28 September 2026

Section 16 Planning Application for Proposed Mixed-Use Development (Proposed Flat with Permitted Commercial Uses) with Minor Relaxation of Building Height Restriction at Lot 4354 in D.D. 124, Kiu Tau Wai, Yuen Long (Application No. A/HSK/617)

Response to Departmental Comments

Checked	DH	Drawn	PW
Rev	0	Date	Sep 2026
Scale	Figure 5.7

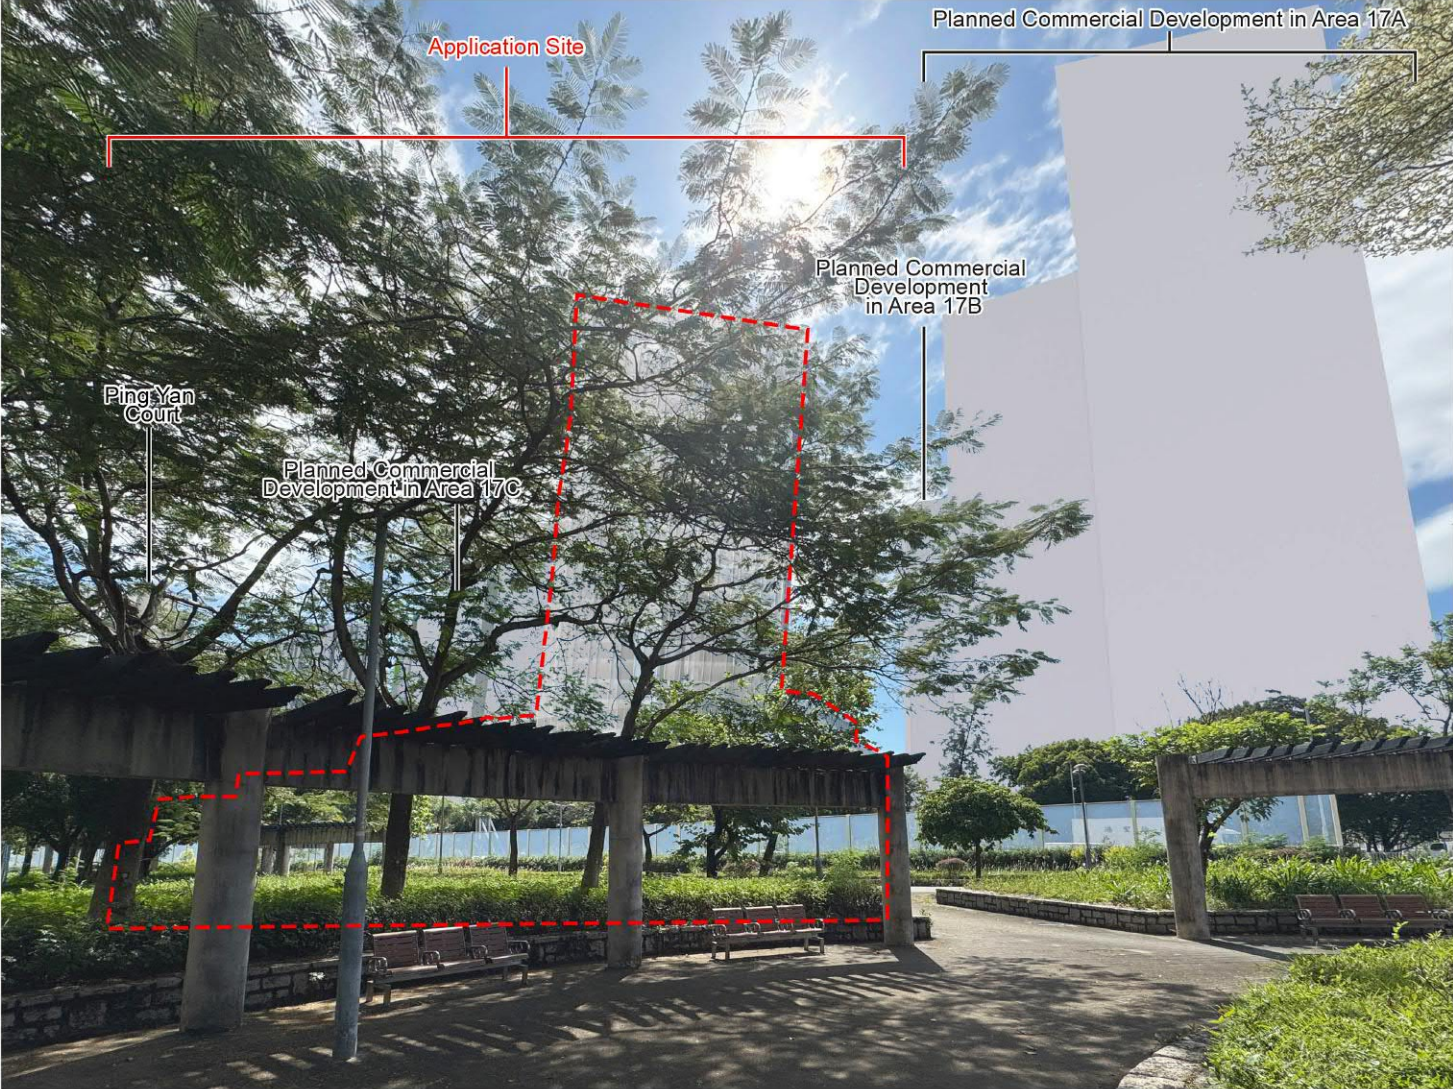
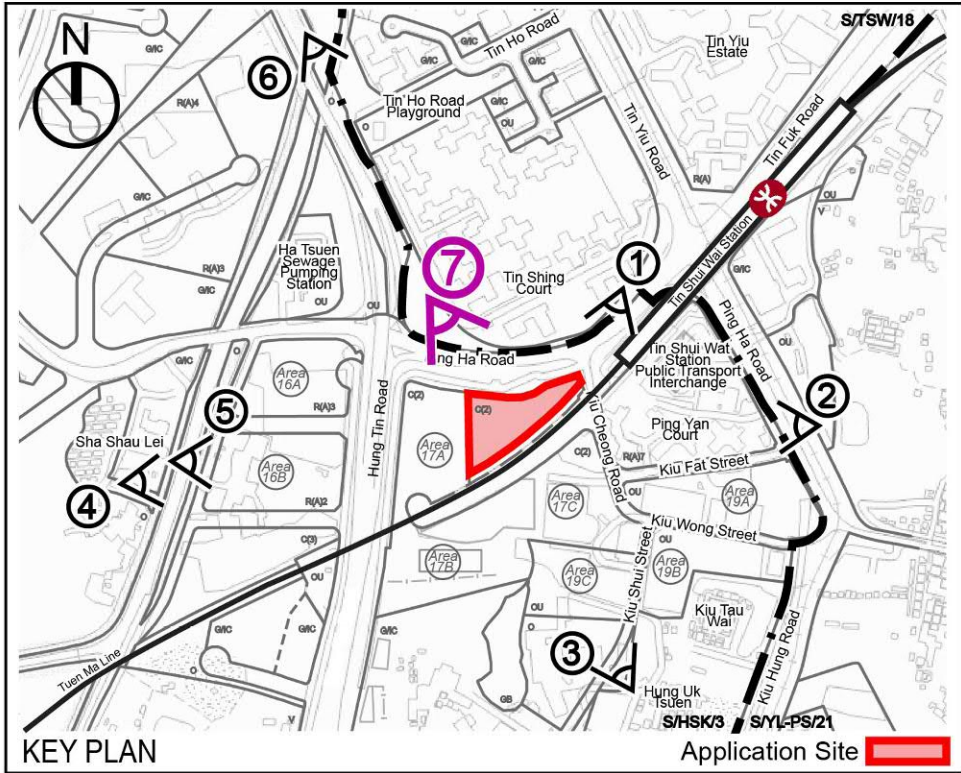
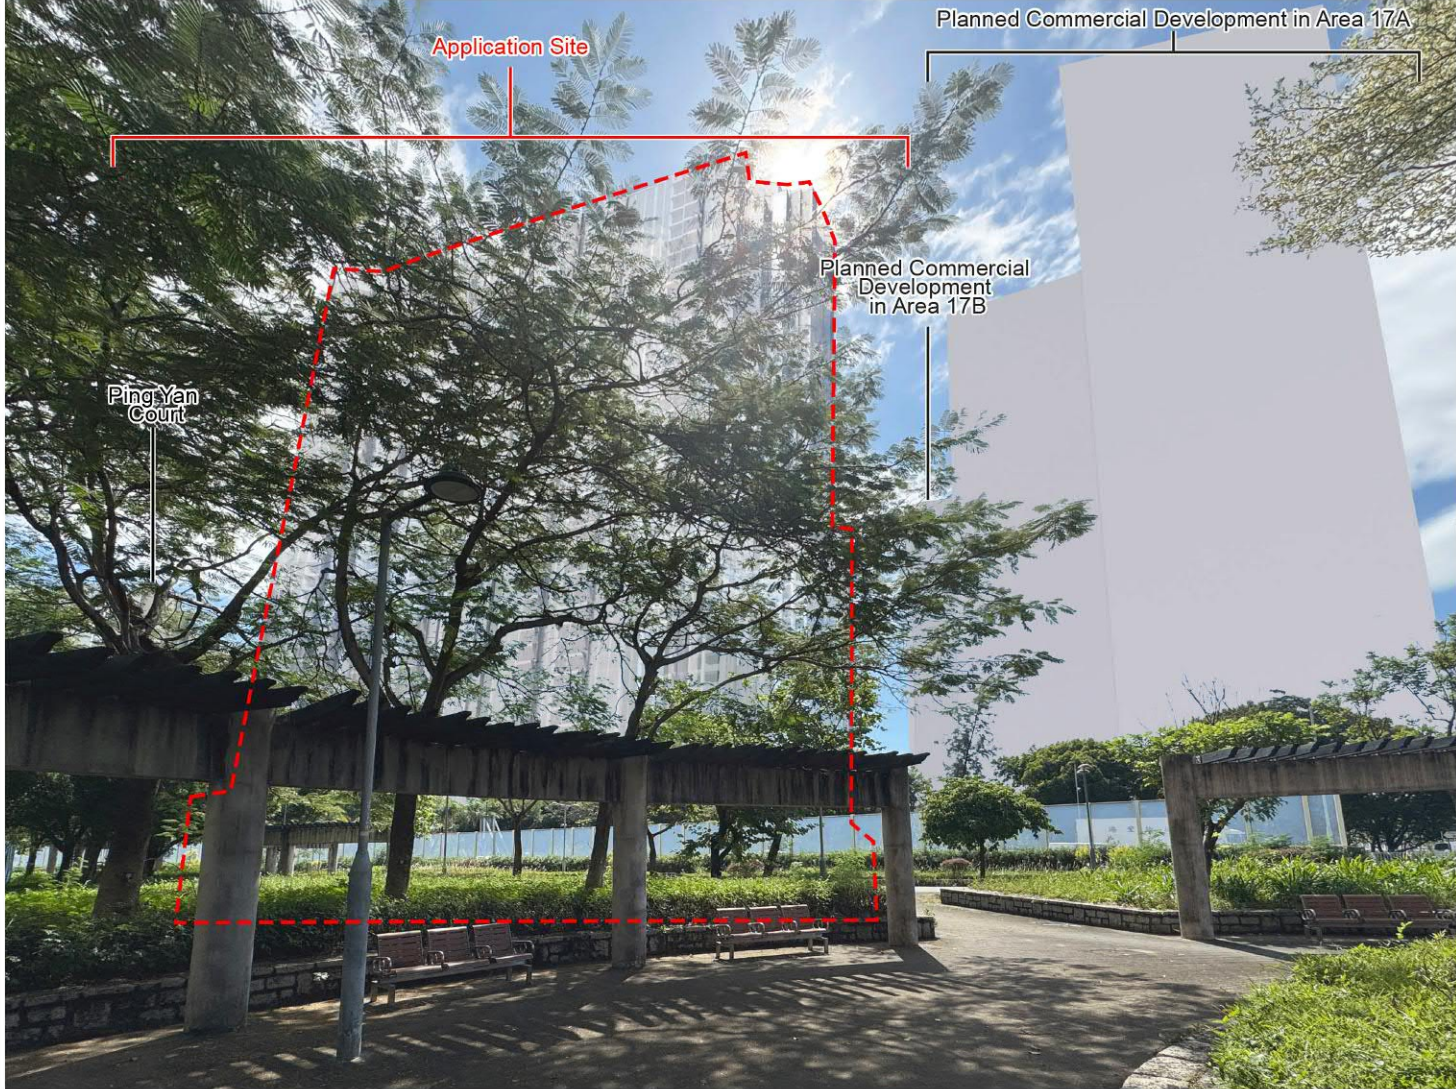
Departmental Comments	Responses to Comments
7.	Comments of Planning Department – Urban Design and Landscape	
7.1	For the photomontage of VP 7 (Figure 5.7) in the Visual Impact Assessment, the current submission is yet to fully reflect the scale of the proposed development which appears to be taller and wider, extending beyond the existing tree line and occupying about two-fifth of the photo width.	Upon further review, the photomontages at VP7 have been fine-tuned and are provided in Attachment 3. These photomontages have been prepared with reference to surrounding visual elements, particularly Ping Tai House of Ping Yan Court, which is visible on the left side of the photos. Supplementary details of the photomontages are set out below to justify the perceived size and height of the proposed development from VP7: • The approximate coordinates of VP7 are N = 834181, E = 818093 (HK 1980 Grid Coordinates) at an altitude of about 7mPD. From VP7, the view towards Ping Tai House of Ping Yan Court will not be entirely obstructed by the Proposed Development and will remain visible; • As for building height, Ping Tai House has a BH of about 117mPD and is located approximately 280m from the VP, whereas the proposed residential tower has a BH of 160mPD and is located about 140m (at its western tip) to 180m (at its eastern tip) from the VP. Taking into account their respective BHs and distances from the VP, through extrapolating the height of the Proposed Development, it is estimated that the proposed development will appear slightly more than double the height of Ping Tai House from VP7. Based on our estimations above, the photomontages at VP7 have been fine-tuned and provided in Attachment 3.

FIGURE 3.1

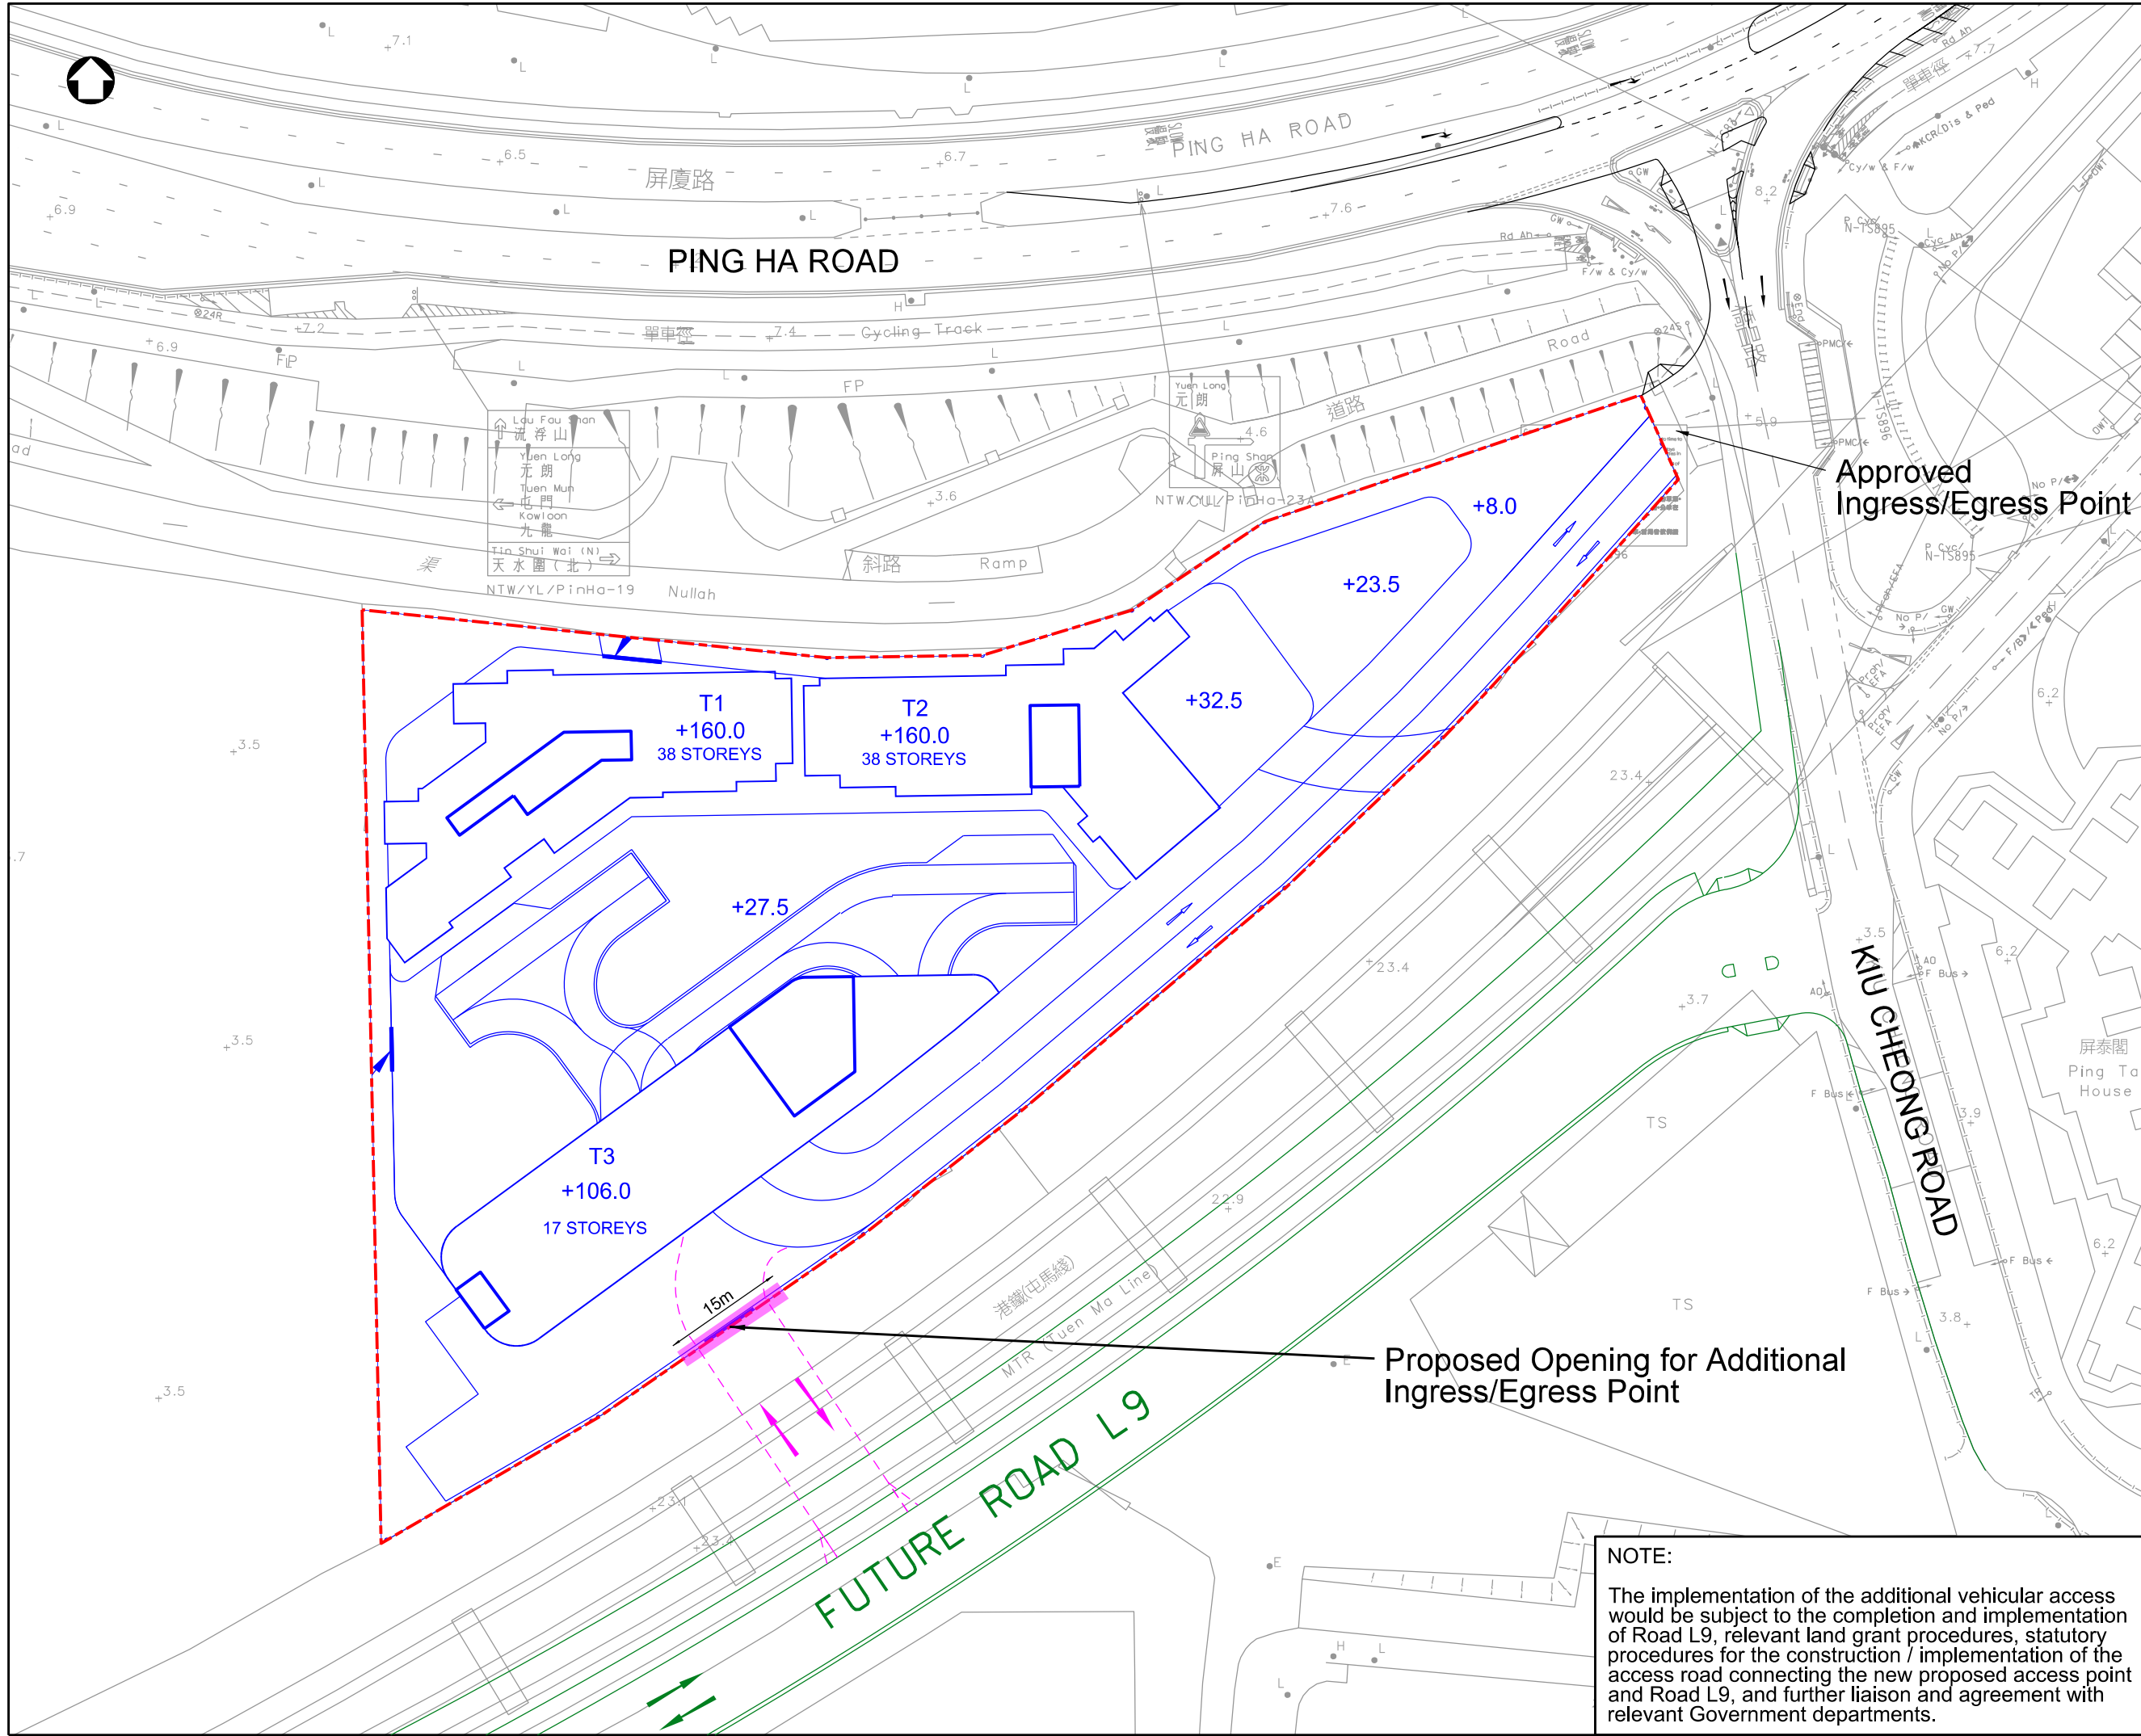
Departmental Comments	Responses to Comments
8.	Comments of Transport Department	
8.1	Figure 3.1 - As the land use of the subject development is proposed to be changed from purely commercial to a mixed development (residential & commercial), the original vehicular access point at Kiu Cheong Road is considered insufficient and not wide enough to cope with the mixed traffic flow. As an alternative, an ingress/egress point at Road L9 should be adopted instead. Given that the current report states this is subject to “further study and detailed design”, the applicant shall confirm such access at Road L9 arrangement in the updated report and corresponding drawings.	Beside the originally approved vehicular access point at Kiu Cheong Road, which has been reflected under the executed land grant of the subject Lot No. 4354 in D.D. 124, in order to allow flexibility in future to implement some possible traffic management measures such as segregation of commercial and residential traffic flows, it is proposed to provide an additional vehicular access to the south of the Proposed Development connecting with the future Road L9. However, the programme of Road L9 is still uncertain and only anticipated to be completed by year 2032, which is beyond the scheduled completion year of the Proposed Development in 2030. As such, implementation of the additional vehicular access would be subject to the completion and commissioning of Road L9, relevant land grant procedures and statutory procedures (if any) associated with the new access road connecting the Proposed Development with Road L9, and further liaison and agreement with relevant Government departments are required. Subsequent to the approval of the subject planning application, the Applicant will further liaise with the relevant Government departments on the implementation arrangement of the said vehicular access connecting with the future Road L9 at next stage. However, provision of this additional southern access is not contingent upon completion of the Proposed Development. Minor updates have been made to the relevant paragraphs and drawings of the TIA accordingly. Please refer to the TIA replacement pages under Attachment 4.
